**Stage F1 Road Safety Audit
(RSA)**

Title: **STAGE F1 ROAD SAFETY AUDIT**
For;
N4 Carrick-on-Shannon to Dromod Project.

Client: **ARUP/ Leitrim County Council**

Report reference: **1180R02-Rev 1**

Figure 4.2 – Vertical alignment of mainline at Junction West Roundabout

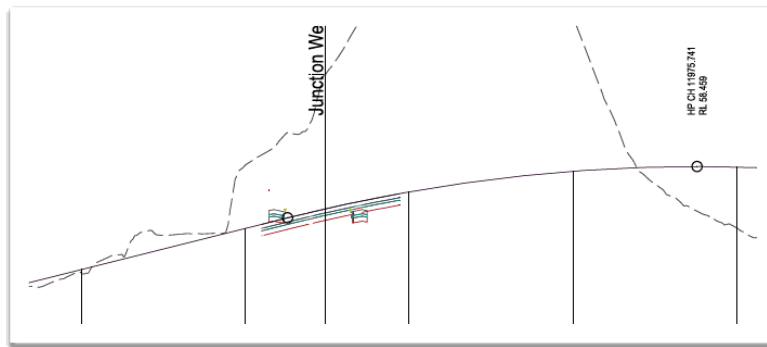
Junction West Roundabout.

Junction West roundabout is located in an area of large cutting and is on the downside of a gradient for westbound traffic. The junction may not be expected by drivers who believe they are in a rural area and who cannot see the roundabout on approach.

The presence of a rural roundabout on a downslope may lead to overshoot by drivers who do not anticipate its presence.

Figure 4.3 - Drishoge, parallel to the railway line

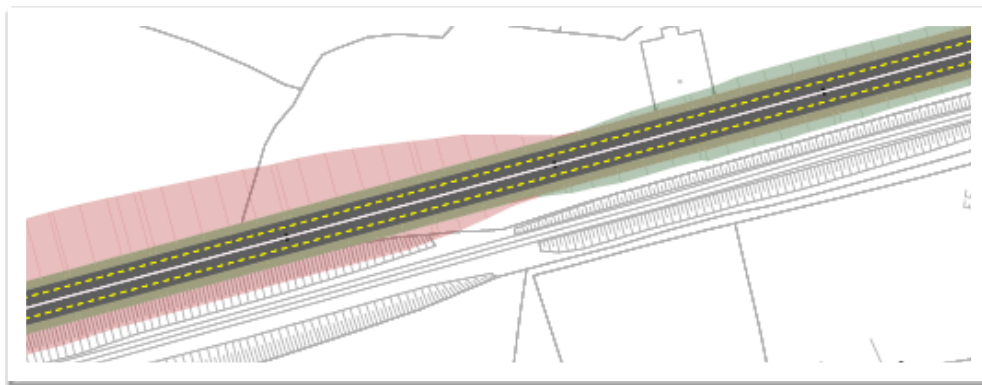
Drishoge, parallel to the railway line (Ch 13,300 to Ch 14,400)

Placing the mainline parallel to the railway line could lead to dazzle for drivers from train lights, and for train drivers from headlights of traffic. This could lead to loss of control for drivers, and for train drivers to be unable to see hazards on the rail line ahead.

Dazzle from parallel road and train line.

Figure 4.4 - Cortober Roundabout

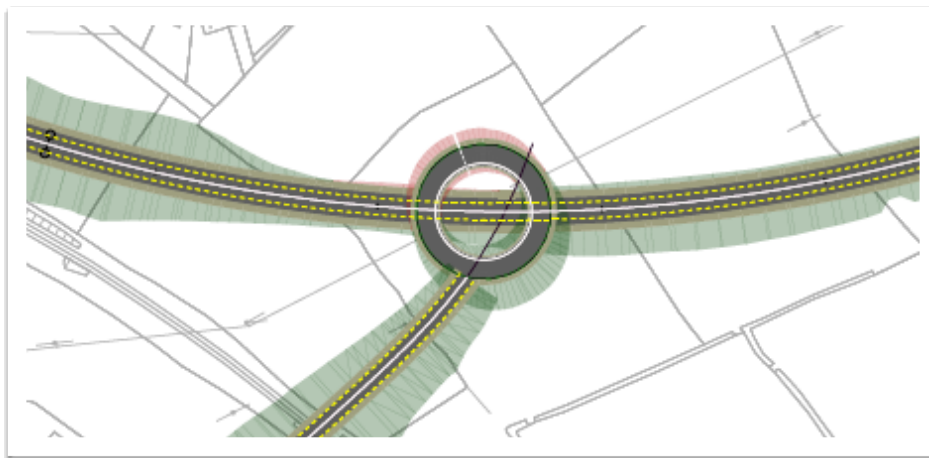
Cortober Roundabout, Ch 14,700.

The realigned R368 arm of the Cortober roundabout is at an acute angle to the east - west realigned N4 mainline. There appears to be a constraint with a perpendicular crossing of the railway line. The acute angle may lead to side-swipe collisions on the circulating carriageway of the roundabout if eastbound N4 mainline drivers misjudge gaps to the R368 traffic entering the roundabout.

Roundabout geometry could lead to side-swipe collisions.

Figure 4.5 - Collector roads either side of N4 mainline Ch 17,300 to Ch 18,900

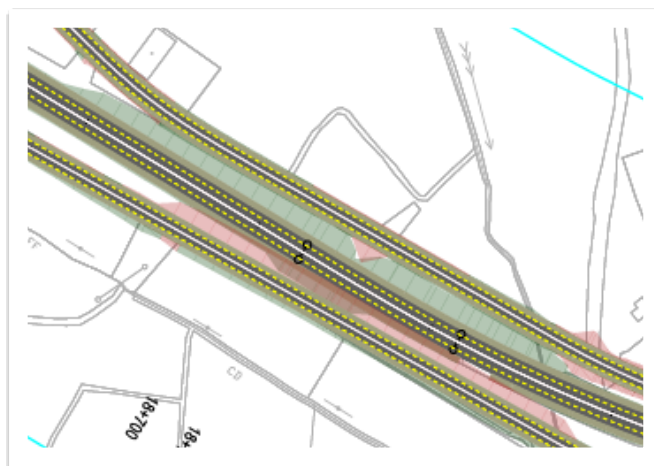
Collector roads either side of N4 mainline Ch 17,300 to Ch 18,900.

The proposed collector roads on both sides of the N4 mainline could lead to dazzle for drivers.

Dazzle from headlights of vehicles travelling in the opposite direction on the collector roads could lead to loss of control.

Figure 4.6 - Vertical Alignment, Ch 20,700 to Ch 21,300

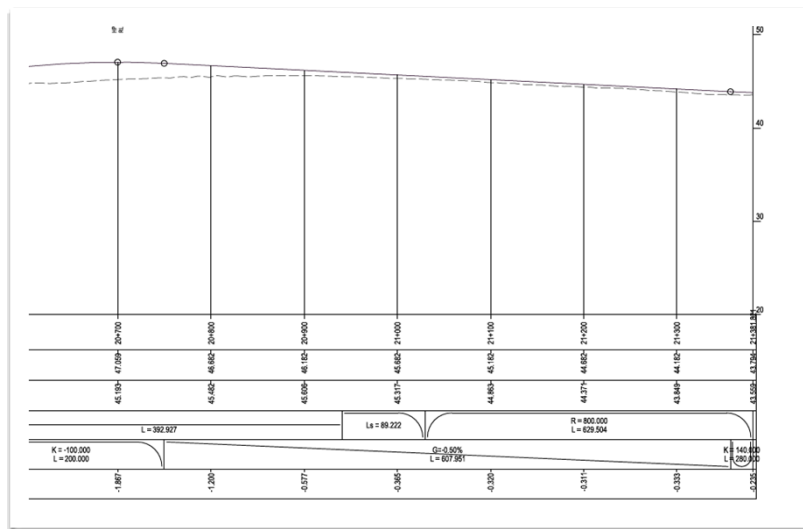
Ch 20,700 to Ch 21,300, Vertical Alignment.

The vertical alignment between Ch 20,700 and Ch 21,300 is very flat. When construction tolerances of the surfacing course are taken into account this could lead to flat spots resulting in surface water ponding.

Surface water ponding in flat areas could lead to loss of traction and loss of control.

Figure 4.9 - Collector roads either side of N4 mainline Ch 17,500 to Ch 18,900

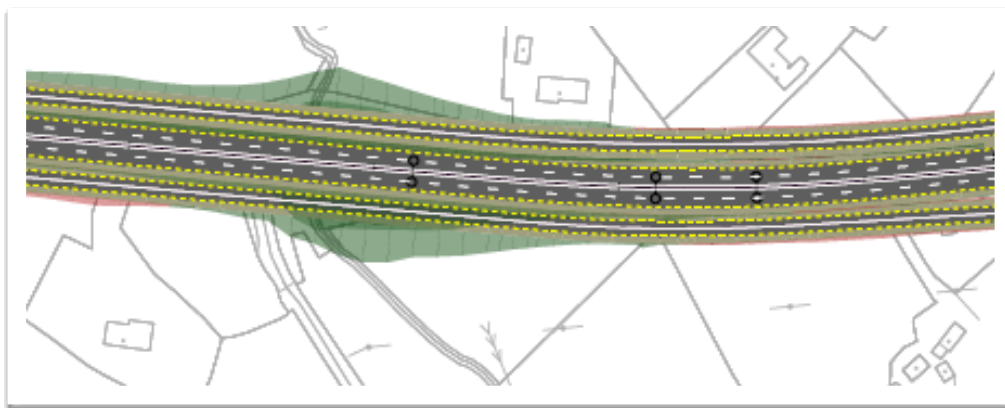
Collector roads either side of N4 mainline Ch 17,500 to Ch 18,900

The proposed collector roads on both sides of the N4 mainline could lead to dazzle for drivers.

Dazzle from headlights of vehicles travelling in the opposite direction on the collector roads could lead to loss of control.

Figure 4.10 - Vertical Alignment, Ch 20,700 to Ch 21,300

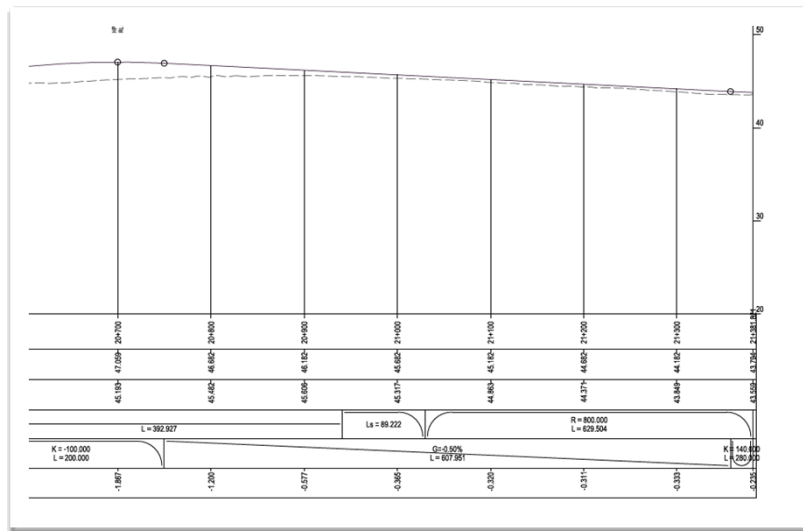
Ch 20,700 to Ch 21,300, Vertical Alignment.

The vertical alignment between Ch 20,700 and Ch 21,300 is very flat. When construction tolerances of the surfacing course are taken into account this could lead to flat spots resulting in surface water ponding.

Surface water ponding in flat areas could lead to loss of traction and loss of control.

Figure 4.12 - R280 grade separated junction

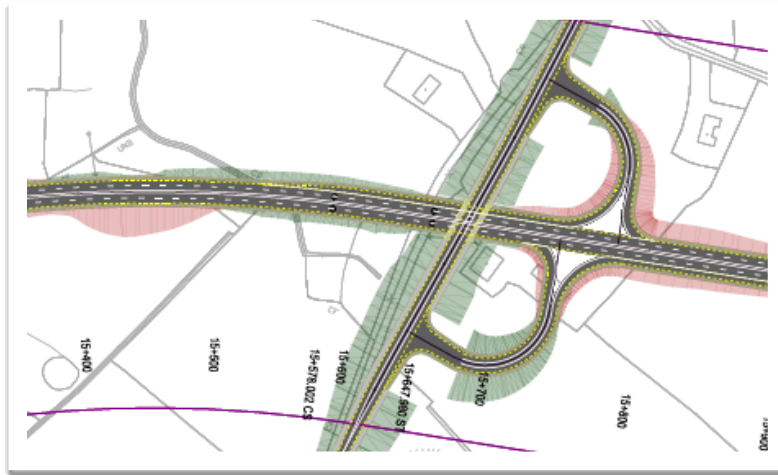
Junctions along the route.

There is a mixture of roundabout and grade separated junctions along the route. The proposed R280 junction is a grade separated junction as is the Drumsna junction, but Node B and Node E are proposed roundabouts. Mainline drivers on the N4 travelling onwards to Sligo or Dublin may not expect to have to negotiate at-grade junctions and may not be alert to these after free flowing through grade separated junctions.

Inconsistent junction types along the route may lead to mainline N4 drivers being less aware of upcoming at-grade junctions at which they must give way.

Figure 4.14 - Vertical Alignment, Ch 17,800 to Ch 19,400

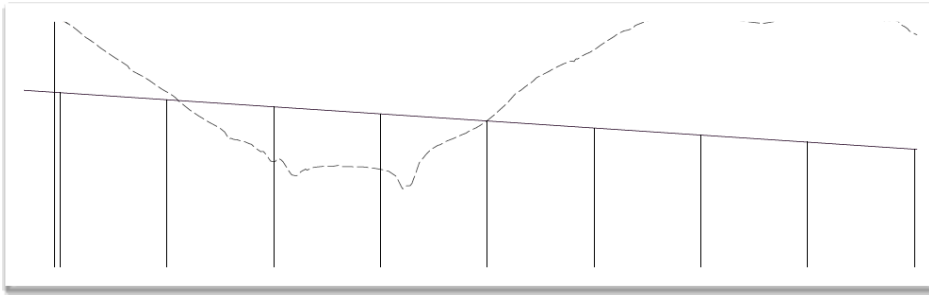
Ch 17,800 to Ch 19,400, Vertical Alignment.

The proposed vertical alignment between Ch 17,800 and Ch 19,400 is very flat. When construction tolerances of the surfacing course are taken into account this could lead to flat spots resulting in surface water ponding.

Surface water ponding in flat areas could lead to loss of traction and loss of control.

Figure 4.15 - R280 grade separated junction

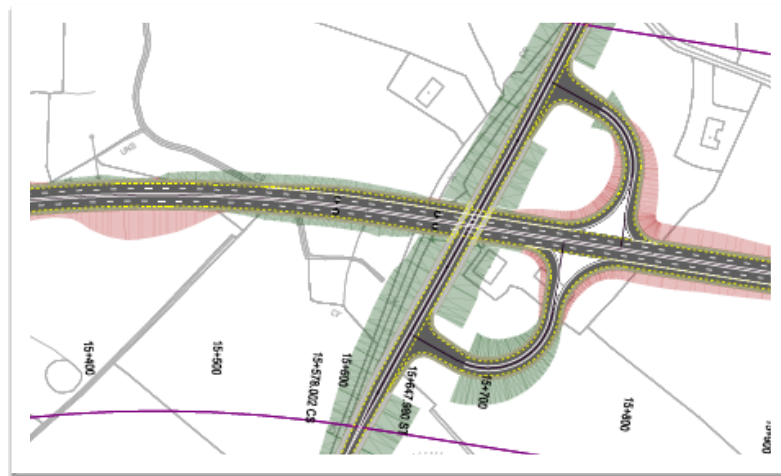
Junctions along the route.

There is a mixture of roundabout and grade separated junctions along the route. The proposed R280 junction is a grade separated junction as is the Drumsna junction, but Node B and Node E are proposed roundabouts. Mainline drivers on the N4 travelling onwards to Sligo or Dublin may not expect to have to negotiate at-grade junctions and may not be alert to these after free flowing through grade separated junctions.

Inconsistent junction types along the route may lead to mainline N4 drivers being less aware of upcoming at-grade junctions at which they must give way.

Figure 4.17 - Drumsna Junction

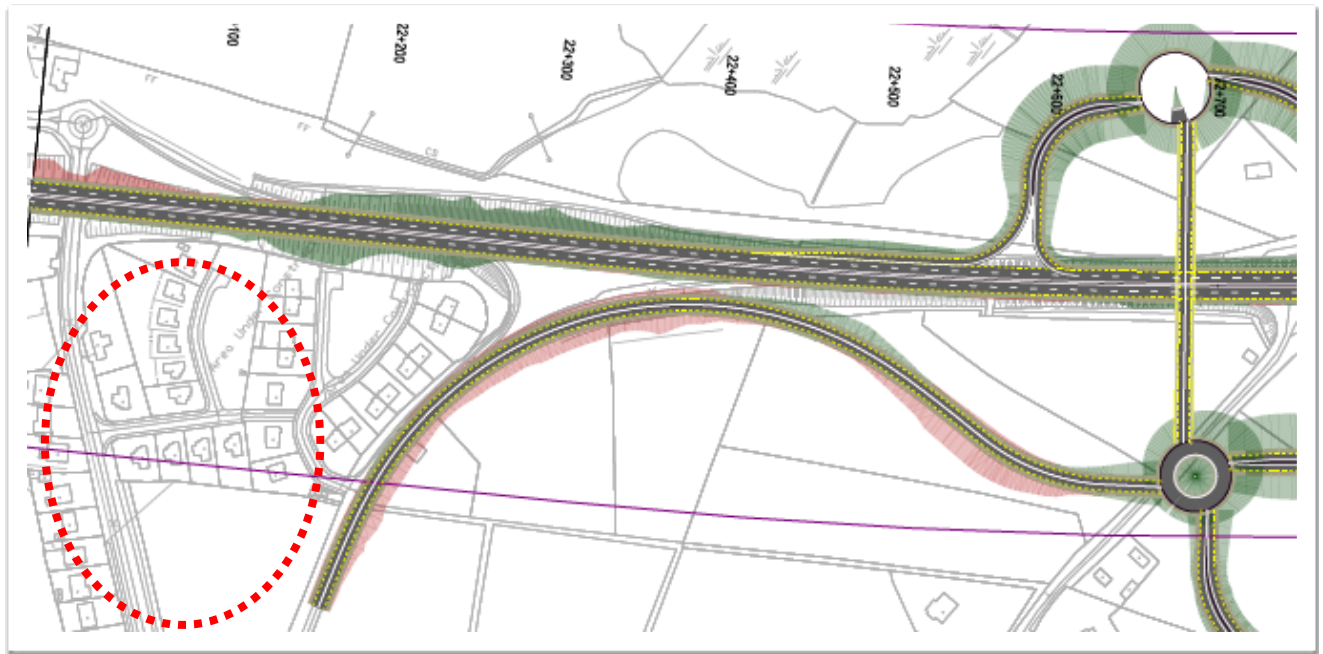
Drumsna Junction.

Without an eastern link to the R299 unnecessary heavy traffic would be brought through Drumsna Village.

Mixing of heavy vehicles and vulnerable road users in urban areas leads to higher collision rates and more severe collisions.

Figure 4.18 - Collector road north of N4 mainline

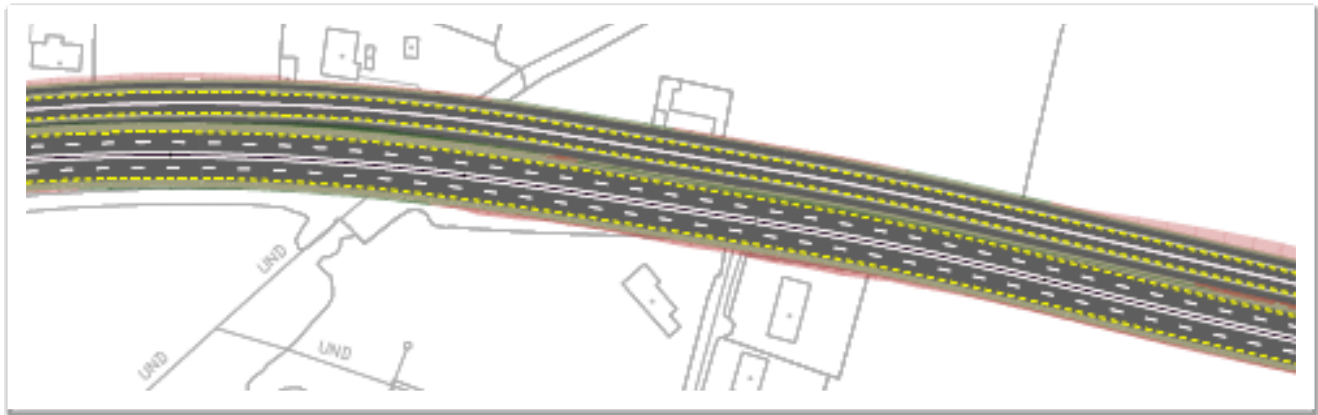
Collector road north of N4 mainline, Ch 24,400 to Ch 26,200 & Ch 27,000 to Ch 28,700 and collector road south of mainline from Ch 27,800 to Ch 29,100.

The proposed collector roads north and south of the N4 mainline could lead to dazzle for drivers.

Dazzle from headlights of vehicles travelling in the opposite direction on the collector road could lead to loss of control.

Figure 4.19 - Collector road north of N4 mainline, Ch 24,400 to Ch 26,200

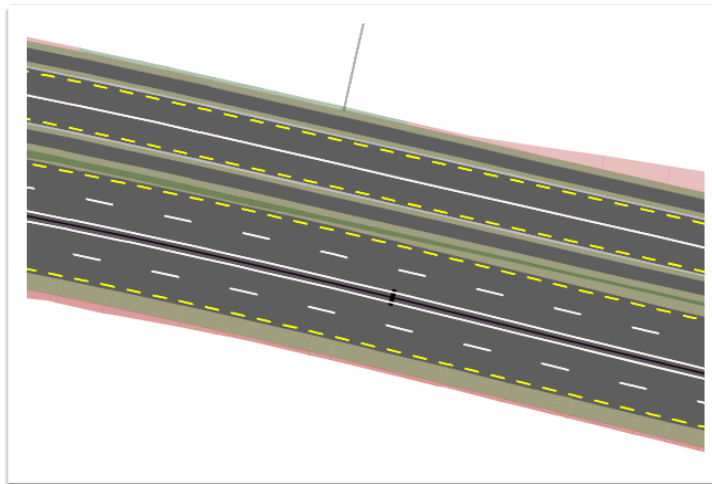
Collector road north of N4 mainline, Ch 24,400 to Ch 26,200.

The proposed collector road north of the N4 mainline could lead to excessive use of vehicle restraint systems if the Clear Zone is not provided between the N4 mainline and the collector road.

Vehicle restraint systems are hazards for the occupants of errant vehicles.

Figure 4.20 - L7430 tie-in

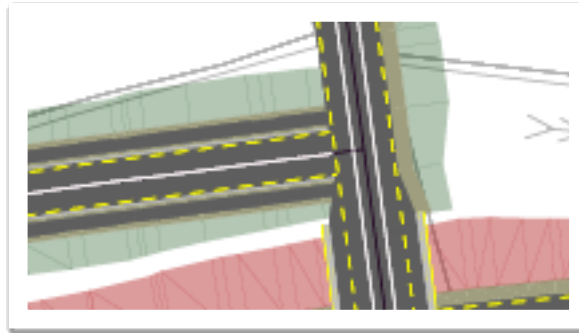
Collector road north of N4 mainline, Ch 24,400 to Ch 26,500.

It is proposed to provide pedestrian/cycle facilities both sides of the collector road from the L7430 tie-in to the Aghamore grade separated junction. The proposed facilities stop at both ends without continuity to other facilities.

Discontinuities in facilities for vulnerable road users can lead to sharing of space with general traffic and increase the likelihood of collisions.

Figure 4.21 - Aghamore

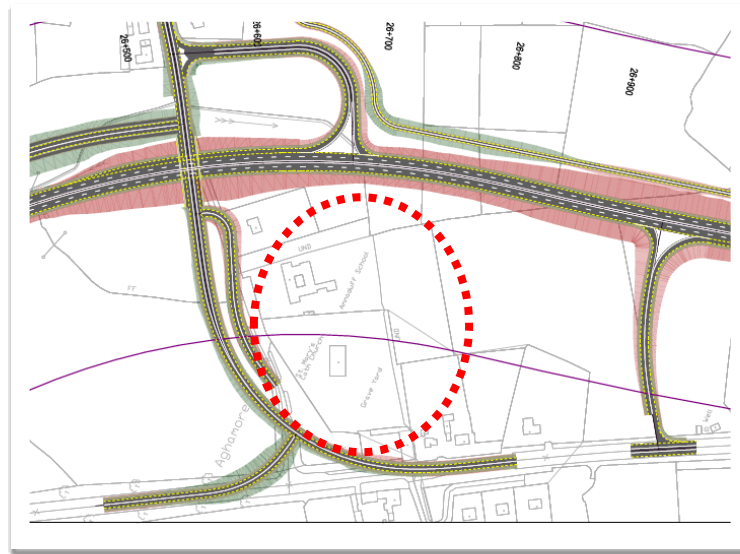
Annaduff.

The realignment of the N4 at Aghamore will split the Annaduff community. The overbridge of the grade separated junction along with the sweeping horizontal alignment to connect with the existing N4 will lead to a higher speed environment adjacent to the School and Church. That environment will not be suitable for vulnerable road users.

Unsuitable road layouts in urban areas will lead to higher speed, mixing of heavy vehicles and vulnerable road users and will result in higher likelihood of collisions.

Figure 4.22 - Aghamore junction

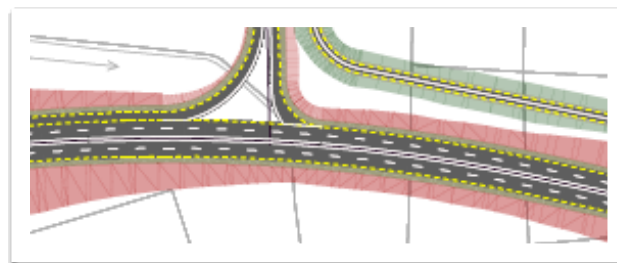
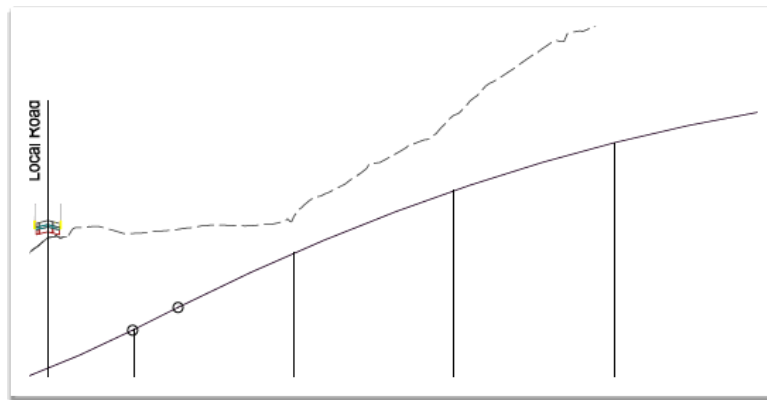
Aghamore junction.

The mainline at the left out of the eastbound Aghamore junction has a proposed vertical alignment of approximately 5%. This will lead to difficulties for heavy vehicles to accelerate once they enter the mainline.

Slow moving heavy goods vehicles could lead to rear-end collisions.

Figure 4.24 - Collector roads north and south of mainline

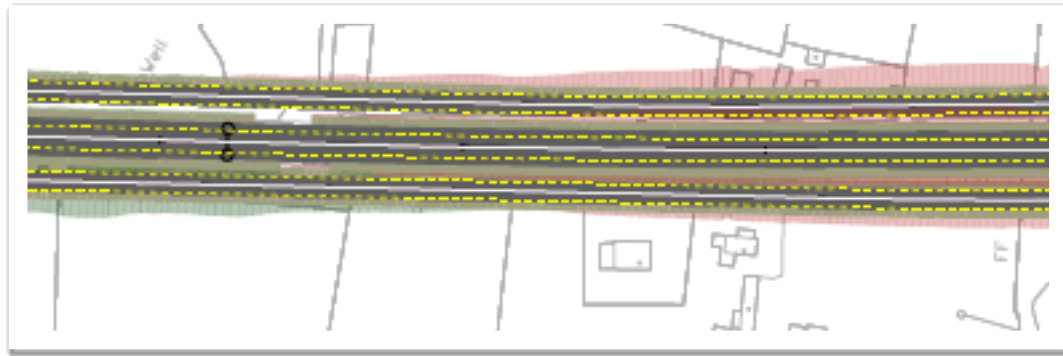
Collector Road north of N4 mainline, Ch 24,400 to Ch 26,000 & Ch 26,500 to Ch 27,400 and collector road south of mainline from Ch 25,500 to Ch 26,200.

The proposed collector roads north and south of the N4 mainline could lead to dazzle for drivers.

Dazzle from headlights of vehicles travelling in the opposite direction on the collector road could lead to loss of control.

Figure 4.25 - Aghamore junction

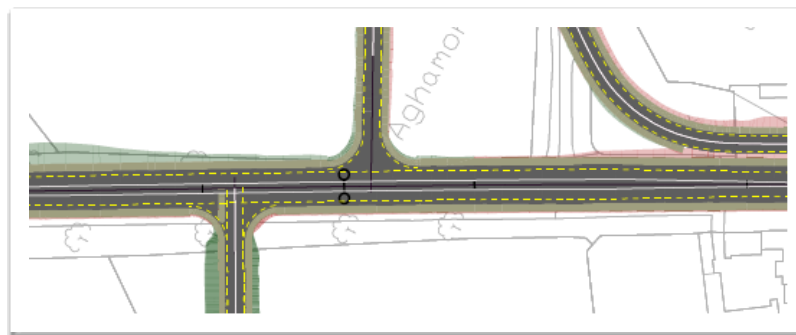
Aghamore junction.

The mainline at the eastbound Aghamore junction has a proposed vertical alignment of approximately 6% uphill. This will lead to difficulties for heavy vehicles to accelerate once they enter the mainline.

There is the same gradient downhill to the westbound exit off the N4. This steep gradient will lead to longer braking distances and possible overshoot of the junction or loss of control.

Slow moving heavy goods vehicles could lead to rear-end collisions. Deceleration on a steep downhill gradient could lead to loss of control.
